**ASHLAND PLANNING DIVISION
PRE-APPLICATION CONFERENCE
COMMENT SHEET July 24, 2019**

SITE: 707 Ashland Creek Dr.
APPLICANT: Trevor Blackmer
OWNER: Neuman Properties
REQUEST: Physical & Environmental
Constraints Review Permit &
Exceptions to Hillside
Standards

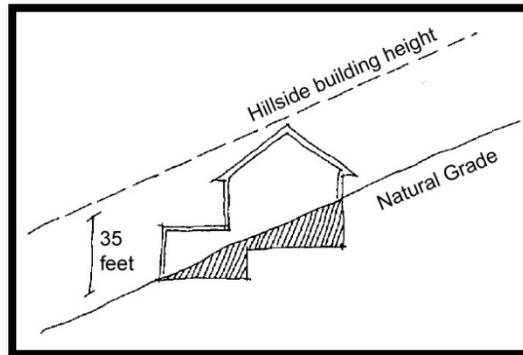
Generally speaking, slopes greater than 35 percent shall be considered unbuildable and the Hillside Development Standards encourage development in a portion of the lot that has slopes of less than 35%. However, based on the topography of the property the location may be justified, as it will limit overall site disturbance, and require a short driveway. (Driveways are not allowed to exceed 100' of length in lands of greater than 35 percent).

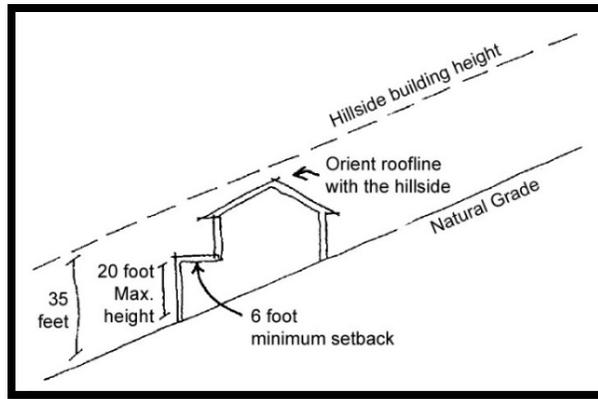
The proposed building appears to generally meet the hillside design standards. Upon initial review the building appears to meet the 35' maximum height but final drawings submitted for the P&E application should make clear the natural grade. The primary south facing curved wall exceeds the 20' maximum height allowed, and the roof over the deck detracts from the effect of the step back. The proposed design either needs to be adjusted to meet the design standard or the application needs to demonstrate that the exception criteria to depart from the Hillside Design Standards are met.
